R06KW

SUBJECT: RECALL R06KW AMMETER SHUNT POWER CABLE BREAKING

Ammeter Shunt Power Cable

MODELS AFFECTED: 2004-2007 Vision with Option 40280-02 Ammeter

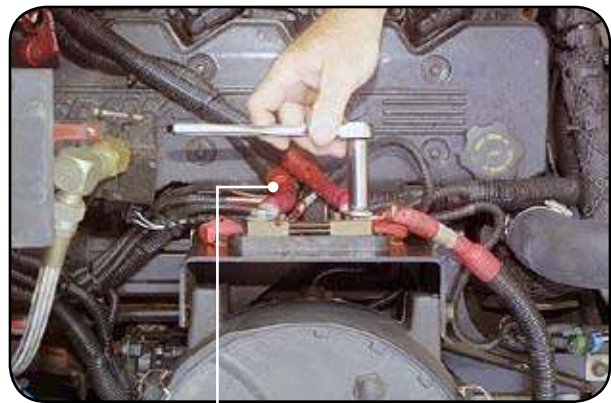
Shunt Assembly
Plastic base will be replaced and re-mounted with through-bolts.

Clearance Varies
If required, the air cleaner mounting bolts will be removed to allow room for a hand and wrench to reach back side of bracket.

Ammeter Cable
Will be replaced if shorter than 20".

2.1 Raise and secure the engine hood. Locate the shunt mounted on left side of air cleaner bracket.

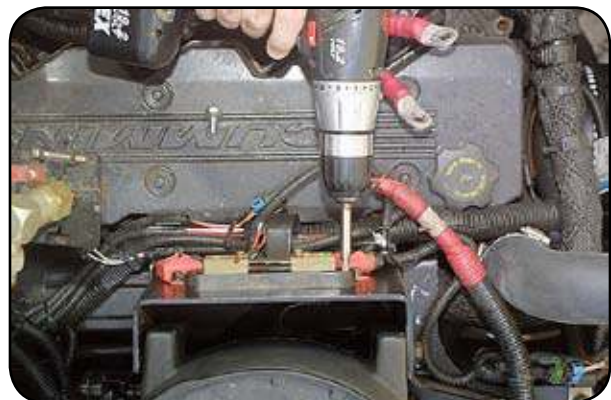
Ammeter Cable
Will be replaced if shorter than 20".

2.2 Remove the cap screws which secure the large power cables to the shunt terminals.

2.3 Remove the two # 14 phillip head screws and flat washers which fasten the shunt base to the air cleaner bracket. Discard screws and washers.

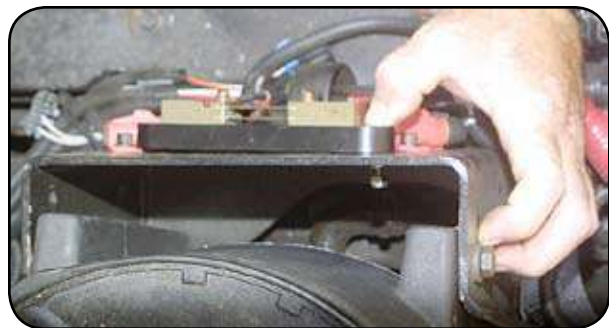
4 Shunt Base Screws
Remove in order to discard existing plastic base. Use red Loctite upon re-installation.

3.1 Rotate the shunt and base assembly downward to see the four screws attaching the plastic base to the metal shunt. Remove and retain these four screws and washers.

3.2 Remove the plastic base and discard.

3.3 Install a new plastic base (part number 0109303) with the four screws and washers removed in step 3.1. Apply red LOCITE 271 to each screw before installing.

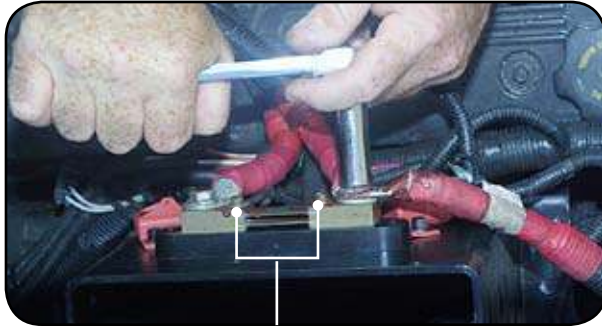
New Base
Will be through-bolted to air cleaner bracket.

5.2 Slide a flat washer (0108776) onto a # 10-24 machine screw (2000768). Insert the machine screw through the new base and the original mounting hole of the air cleaner bracket. From the back side of the bracket, install a flat washer number (0108776) and # 10-24 locknut (1469287) onto the screw, finger-tight.

5.3 Repeat on the opposite end of the shunt. Then tighten the two locknuts to 10-12 in lb.

6 Reattach the power cables which were originally attached to the frontmost terminal of the shunt. Tighten to 90 in lb.

2 Small Signal Lead Screws
Torque: 25-30 in lb.
